**Appeal by Ministry of Justice
Land adjacent to HMP Garth and HMP
Wymott, Leyland Appeal Ref:
APP/D2320/W/22/3295556**

Proof of Evidence of Kevin Riley

on behalf of Chorley Council

TITLE:
ULNES WALTON LANE/A581
PROPOSED MINI ROUNDABOUT
SWEEP PATH ANALYSIS
SHEET 1 OF 6

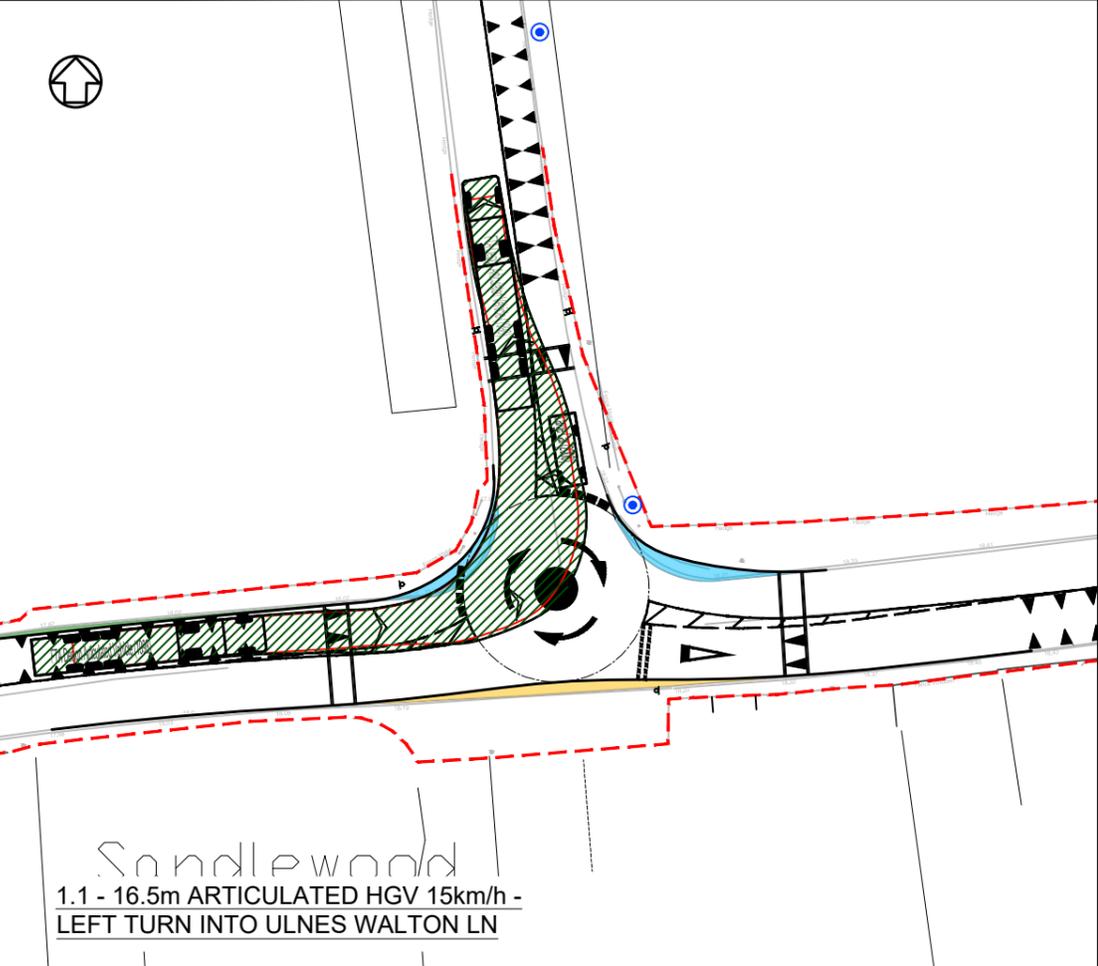
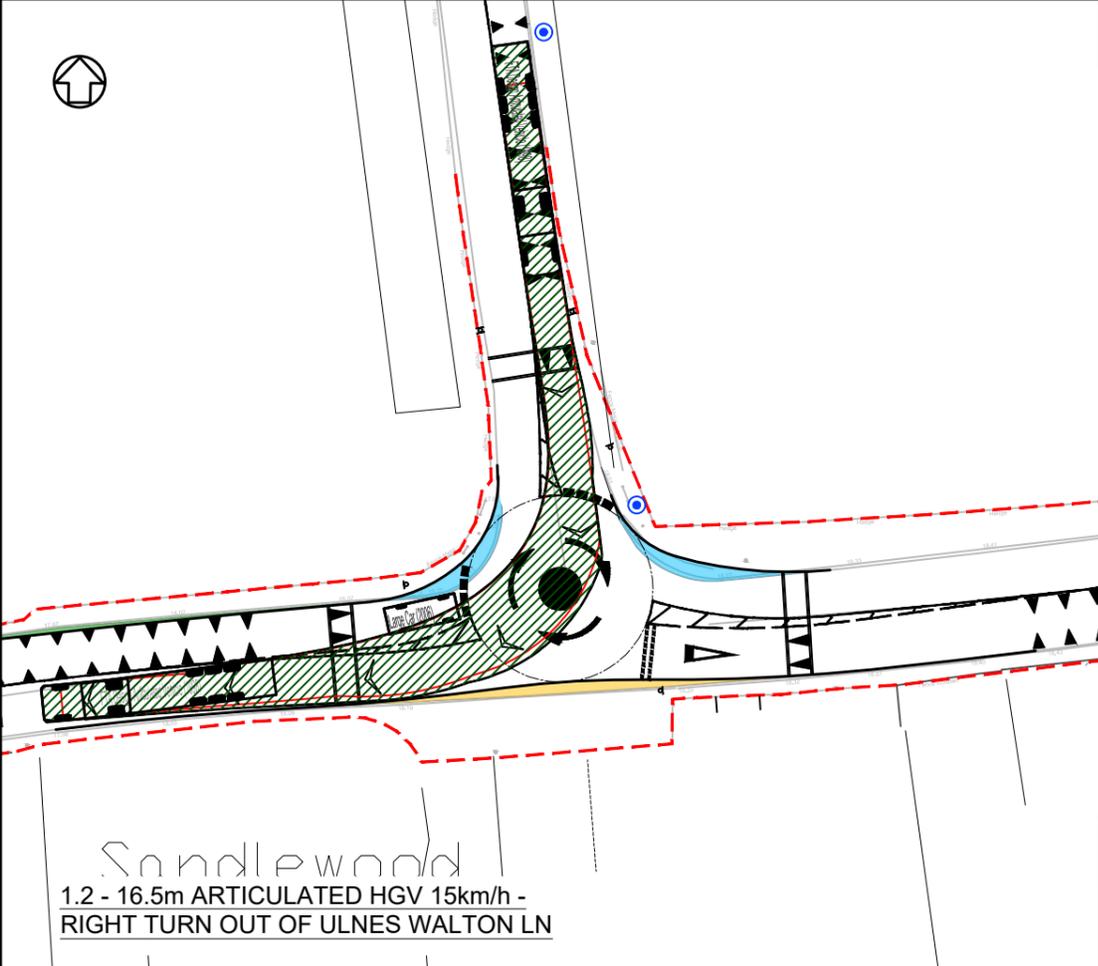
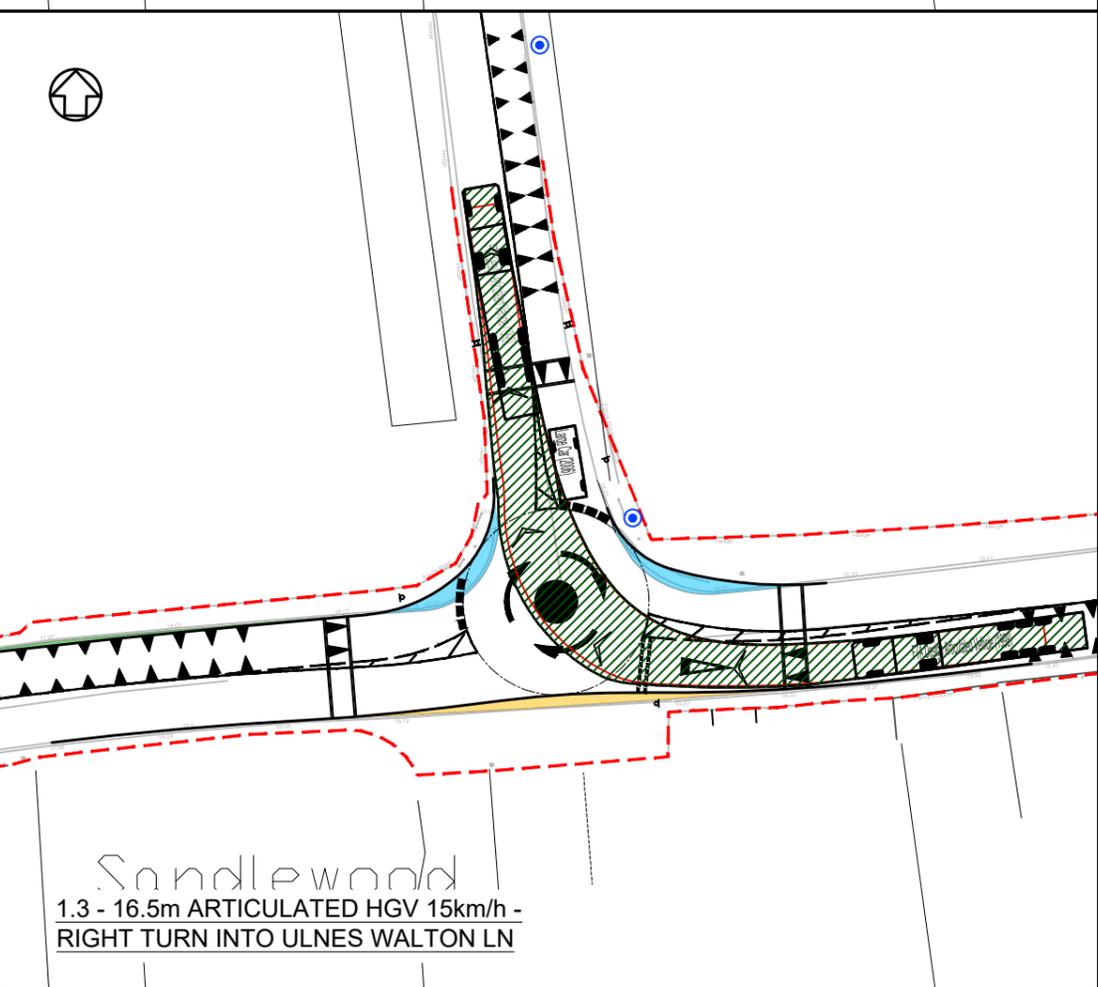
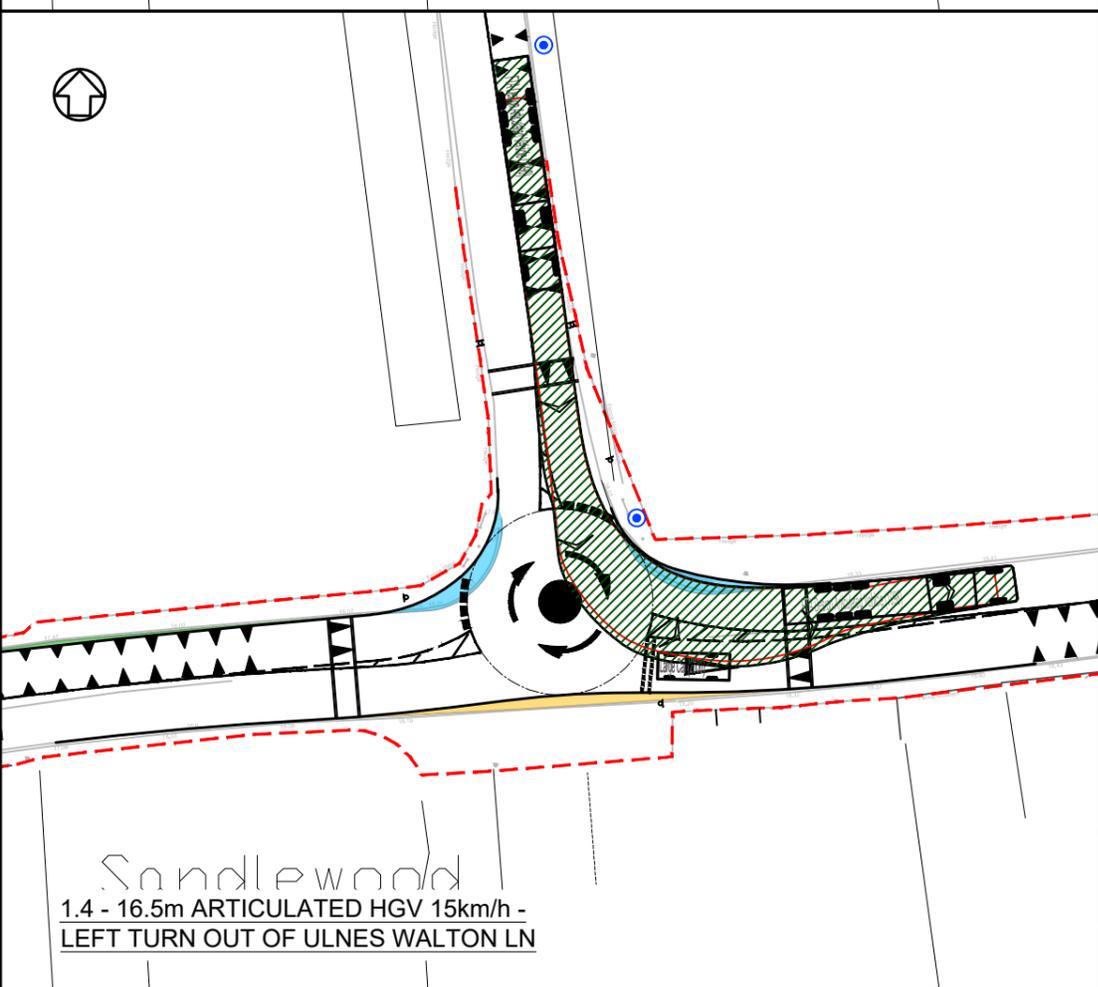
- 5.2.23 The analysis I have undertaken illustrates the turning movements at two speeds, one at 15 kph (approximately 10 mph) and the same at 25 kph (approximately 15 mph) and both show heavy goods vehicles overrun the central markings and into the opposite direction of traffic, with the higher speed of 25 kmph shown to have greater overrun. This means vehicles waiting at the give-way line on each approach will be in potential conflict with vehicles making this manoeuvre and this is not an acceptable safe design of a new junction.

DRAWING No: 7769-WSP-SK-006

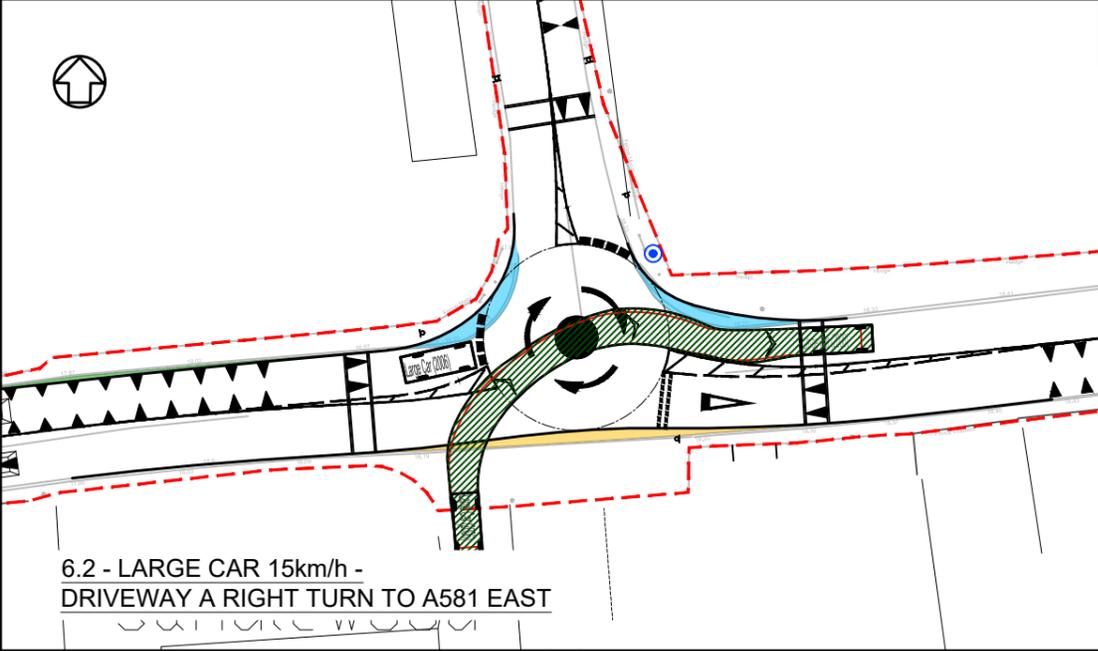
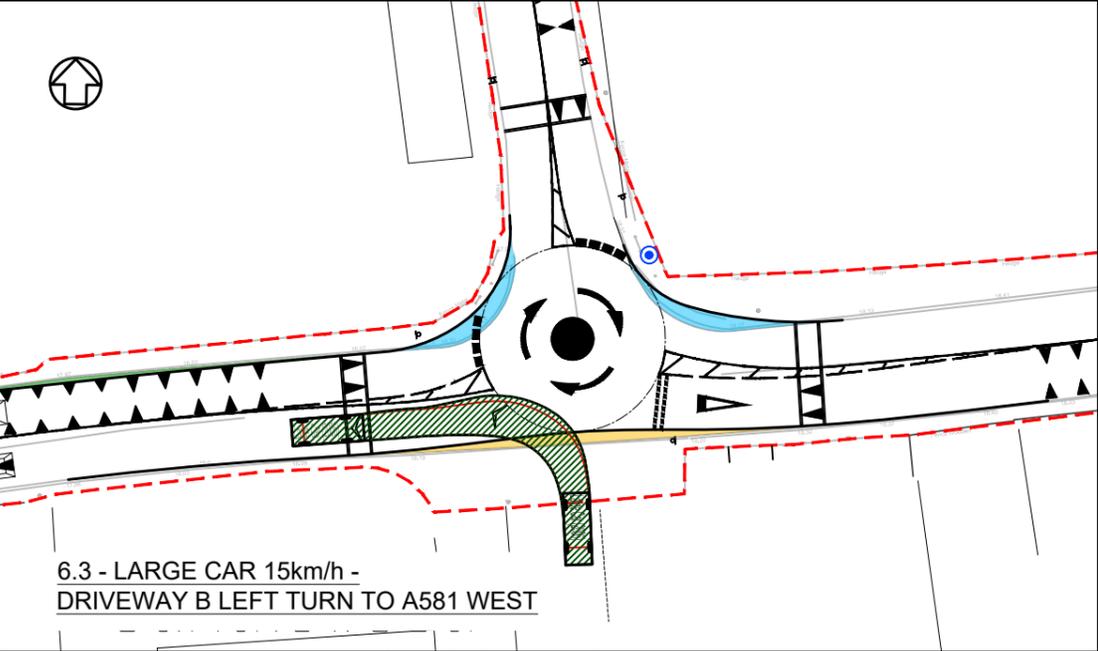
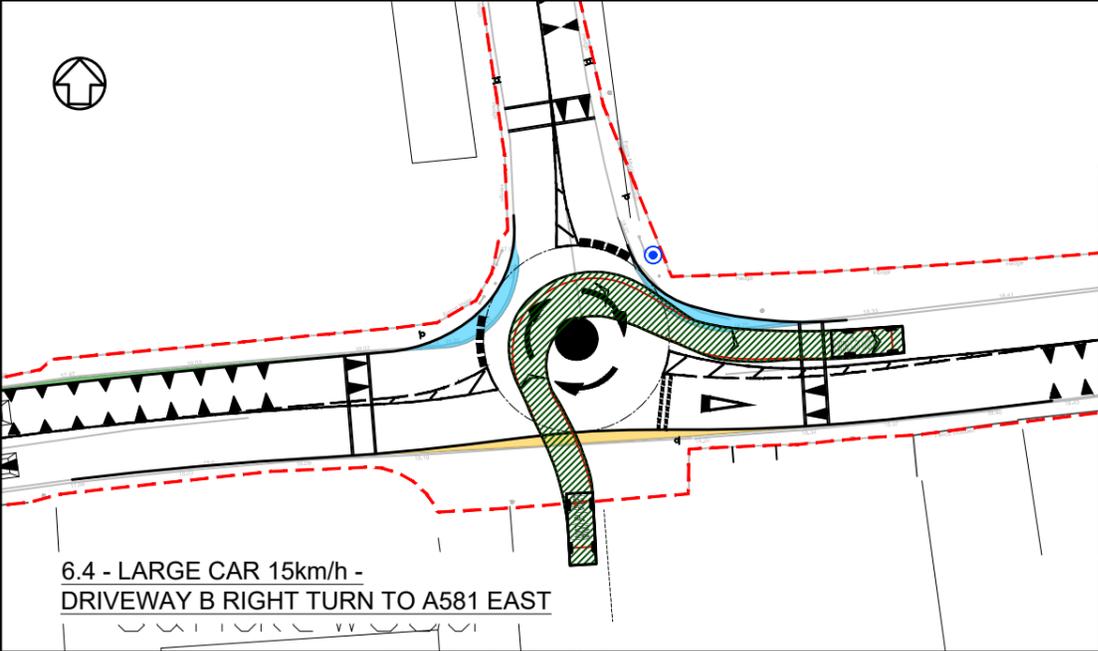
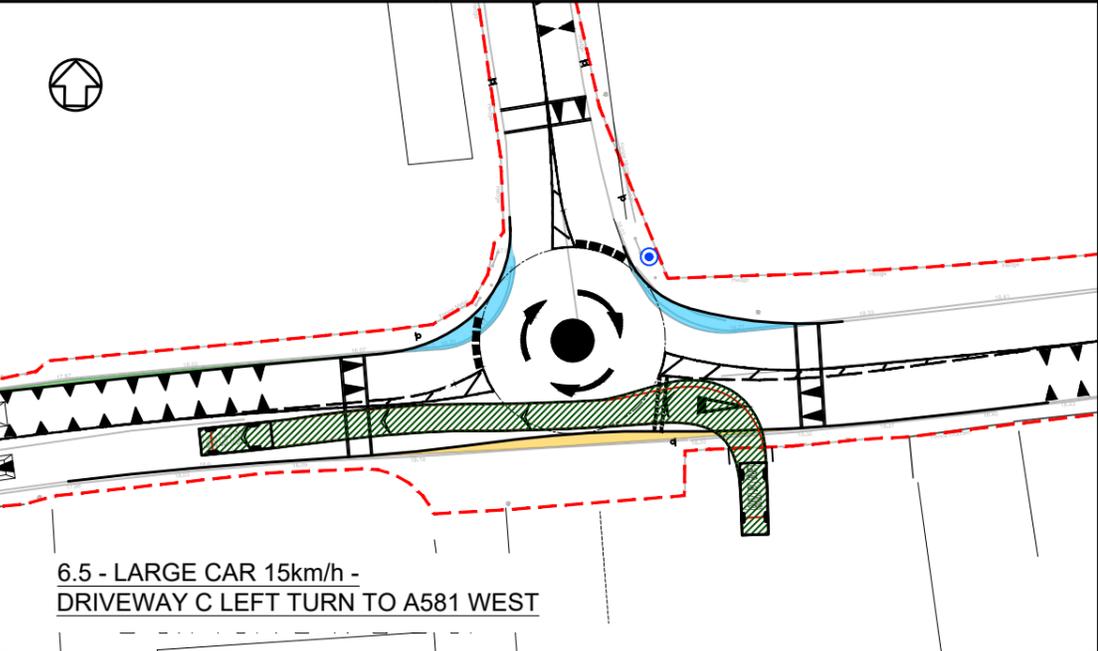
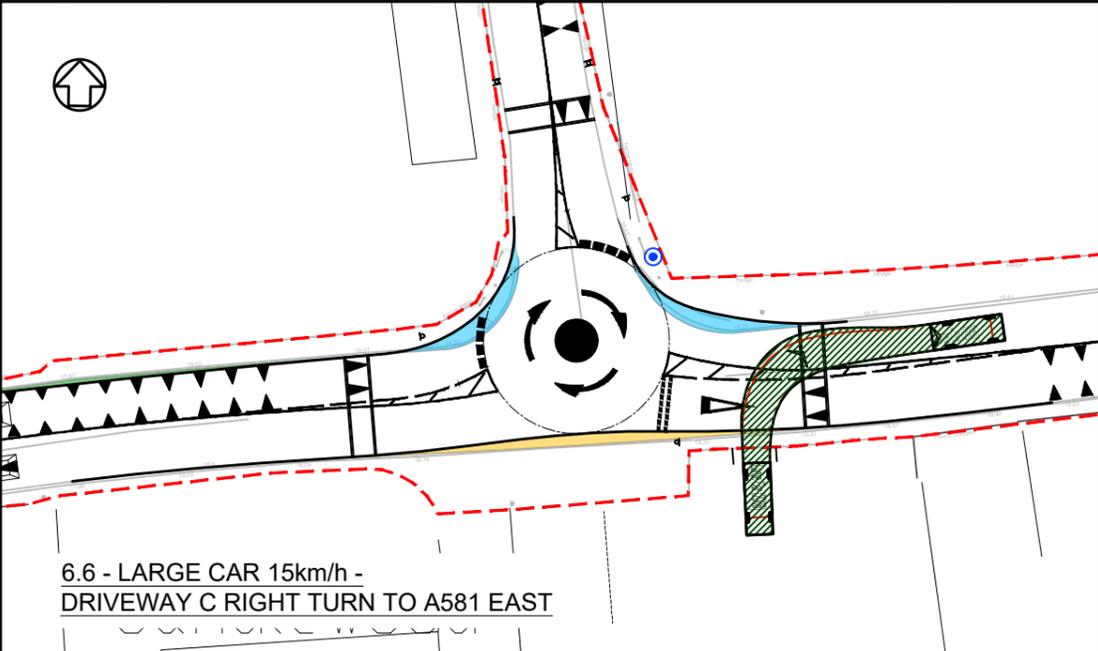
- 5.2.31 Alternatively, as I have illustrated on 7769-WSP-SK-006 in Appendix A, drivers could be tempted to force their way out into traffic (plan 6.2) and potentially sit in the carriageway at 90 degrees to the flow of movements on the A581 waiting for a space to enter the roundabout (plan 6.6). Worse still, drivers could be tempted to cut through the centre of the roundabout. Both of which would be unsafe and increase the risk of accidents and neither are considered acceptable practice.
- 5.2.32 On this basis alone, I conclude that the proposed junction does not meet the necessary standard to mitigate the road safety impacts and this situation will be exacerbated by an increased number of vehicles generated by the proposals, particularly HGVs.
